Findings of Facts, Conclusions of Law, Decision and Order

In the Matter of the Request of Aaron Gross, Value Land, LLC and JP Wagoner Planning for Preliminary Plat with respect to the Artesian Springs Subdivision located at 10348 Hwy 44 (Tax Parcel No. R33916):

Artesian Springs Subdivision

City Engineer & Planner Comments

INDEX PLAN FOR
ARTESIAN SPRINGS SUBDIVISION

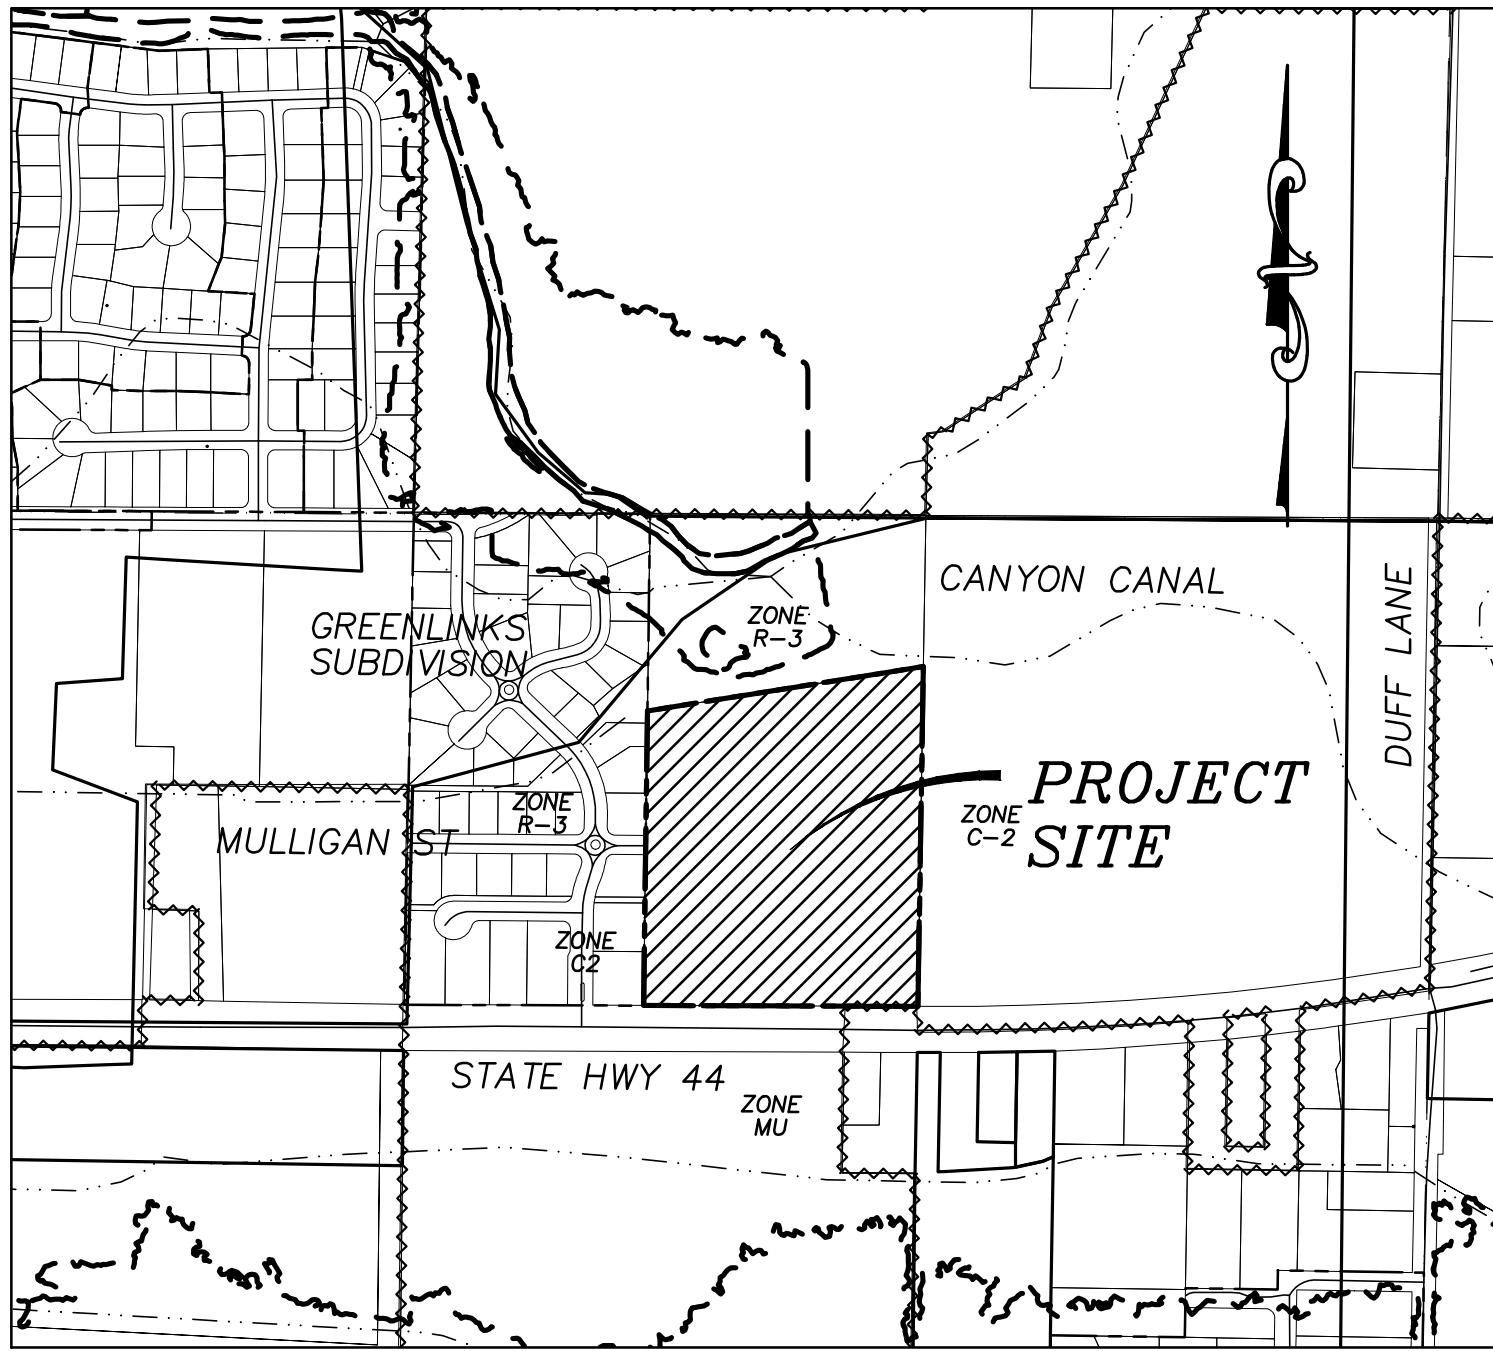
1. **Please condense the plat to fewer pages.**
2. Please add existing zoning information for adjacent parcels.
3. Revise Note 5 to reference Idaho Code and the irrigation district.

4. Dimension irrigation easements (all) and please identify and detail the easement for the irrigation/drainage facility along the east boundary.
5. Please revise Note 6 to specify storm water management to be retention swales.

8. Connect Artesian Springs water main to the water main in Mulligan Street for looping.
9. Plan to develop and construct a pedestrian pathway along, and parallel to, the SH44 right of way.

10. Add pathway in Lot 26 to connect interior street to SH44.
11. Identify Lot 26 as having a blanket public utility and pathway easement.
12. Irrigation does not co-locate in stormwater management areas or other public utility area. Please think through Lot 8 – perhaps it is blanket public utility/stormwater with a designated area for irrigation.

14. Add a note "Subdivision perimeter to be fenced per approved fencing plan" or other similar note stating subdivision perimeter to be fenced.

1. **Review notes (all) and update lot/block numbering.**
2. Please add existing zoning information for adjacent parcels.
3. What is going on with irrigation on the east boundary? Is the drain on Artesian property?
4. Lights installed along SH44 as required. You may add a note and finalize going forward.
5. Need to show irrigation point of delivery/pump station location.

1. Added Bailey Engineering since they were cc'd.
2. Please add "blanket public utility easement" to Lot 19/Block 1.

1. Provide preliminary drainage calculations.
2. Fire Hydrants and streetlights need to be shown on plat, inside subdivision.
3. Show and call out all irrigation/ditch easements in development.

4. Add note: Any re-subdivision of this plat shall comply with the applicable regulations in effect at the time of the Re-subdivision.
5. Need phasing plan with lot breakdown per phase.

6. Work with City Engineer - Roads need to show a turning radius of minimum of 90 ft. Call out in notes.
7. Add a few benches along walking path as amenity. Call out amenity in notes.

8. Add note to call out common areas by lot and block and state who owns them.
9. Add note: All lots are residential building lots except lots (insert L/B)

10. Add cluster mailbox(s) in common area(s). Call out in notes.
11. Provide name of Avenue that will be the loop road through the entire subdivision. There will not be 4 different road names.

12. Add note: All streets proposed in this development are public streets and shall be constructed in accordance with City of Middleton standards.
13. Add note: All existing wells shall be abandoned per IDWR regulations. All septic systems shall be completely removed and the area recompacted per geotechnical report.

14. Add note: Fire protection water shall be provided by the City of Middleton,
15. Add note: Fiber optic to be provided to each lot during Joint Trench construction per the City of Middleton Supplement to the ISPWC.

16. Show all public and private easements on preliminary plat.
17. Vacate Ingress/Egress Easement. Provide agreement showing vacation.
18. Work with City Engineer on irrigation ditch and fence along property line.

19. Add note: Sewer and water capacity shall be reserved when City approves construction drawings.
20. Note 3: Easement can be changed from 15 ft to 10 ft.
